RE: ENGINEER'S CERTIFICATION FOR BOBBY JOE'S AUTO
(H-17/D63) CERTIFICATION REVISION DATED DECEMBER 10, 1991

RE: DRAINAGE PLAN FOR BOBBY JOE'S AUTO
(H-17/D63) ENGINEER'S STAMP DATED JUNE 25, 1991

GRADING AND DRAINAGE PLAN
NEW 40' X 80' OFFICE AND SHOP BUILDING FOR
BOBBY JOE'S AUTO
2505 QUINCY N.E.
ALBUQUERQUE, NEW MEXICO

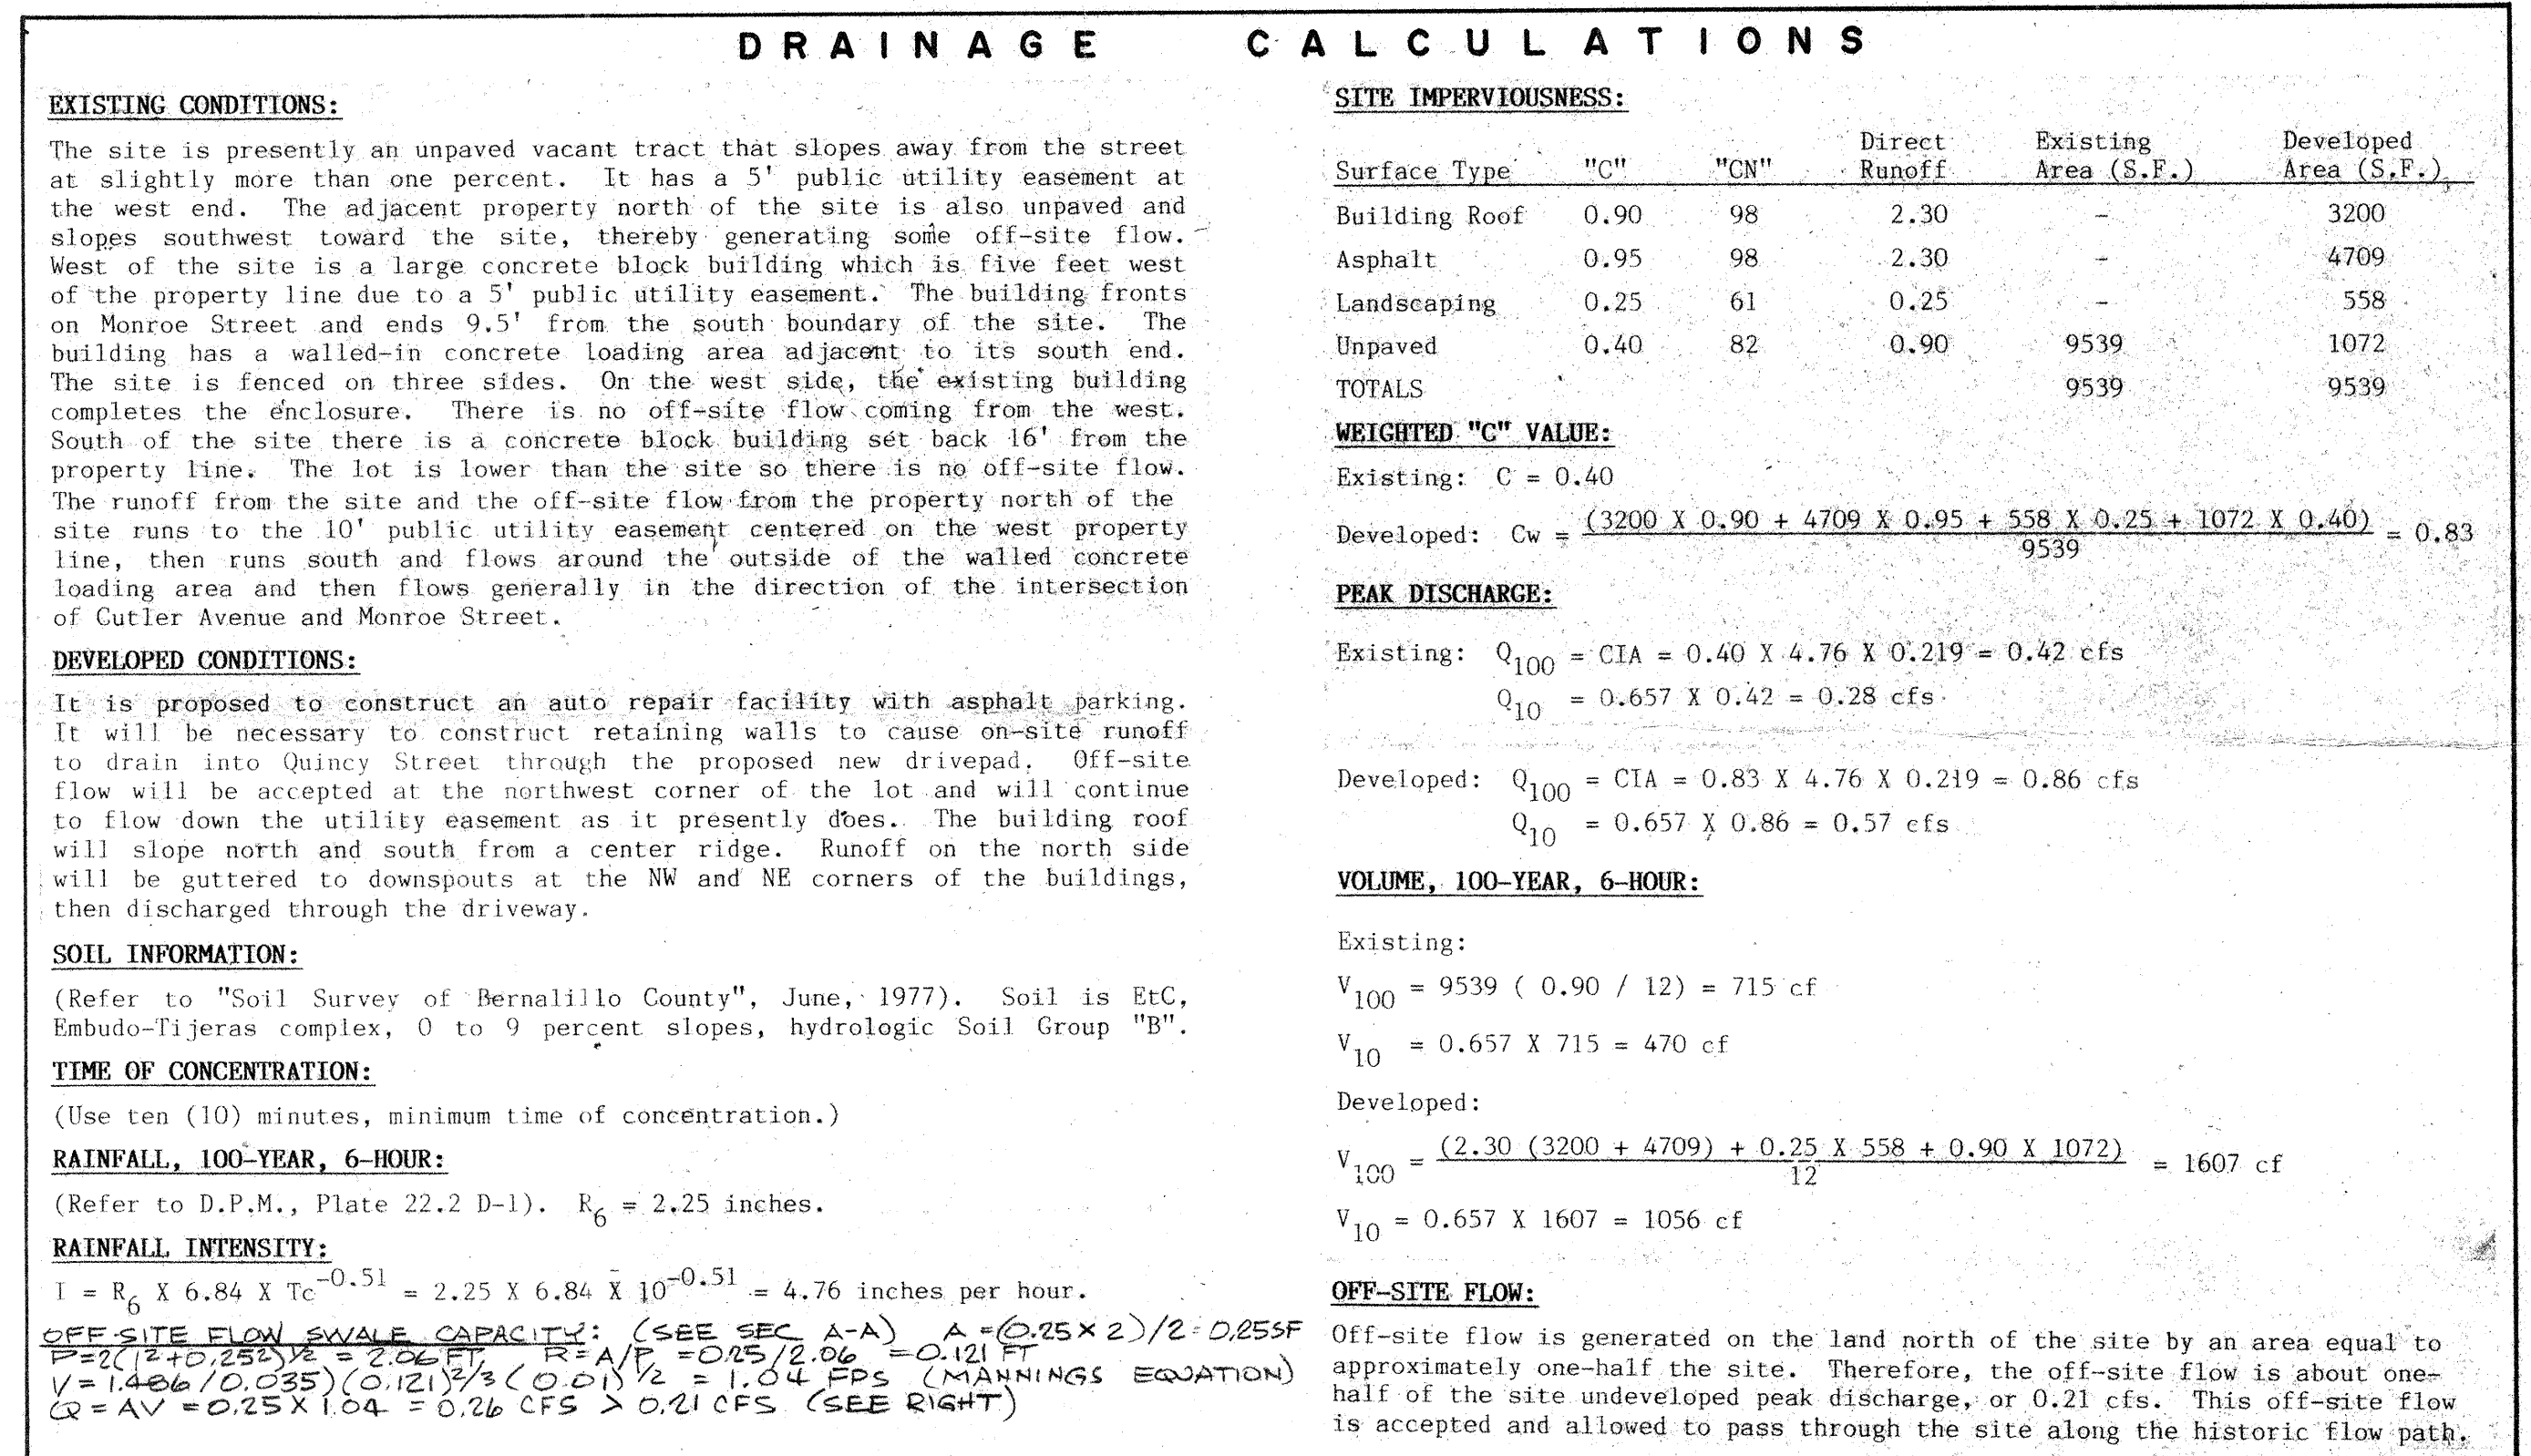
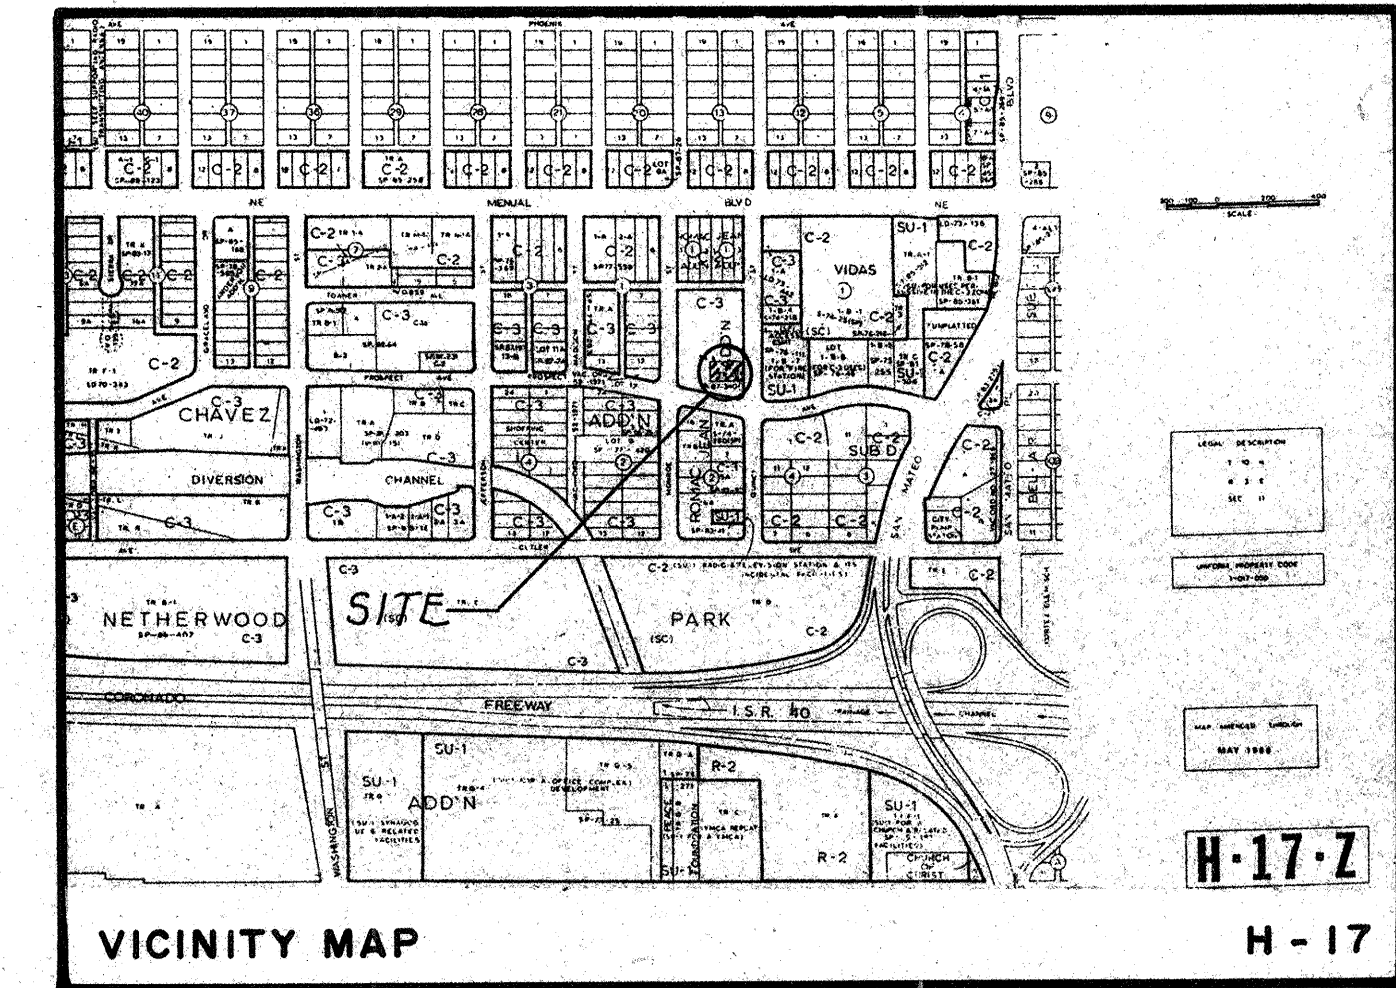
Prior to release of the Certificate of Occupancy, Engineer's Certification per the DPM will be required. A copy of the compaction tests on the proposed berm will be required along with the Certification.

Having completed a field inspection of the site, I hereby certify that the elevations and layout shown on this plan is in substantial compliance with the approved grading and drainage plan dated June 25, 1991.
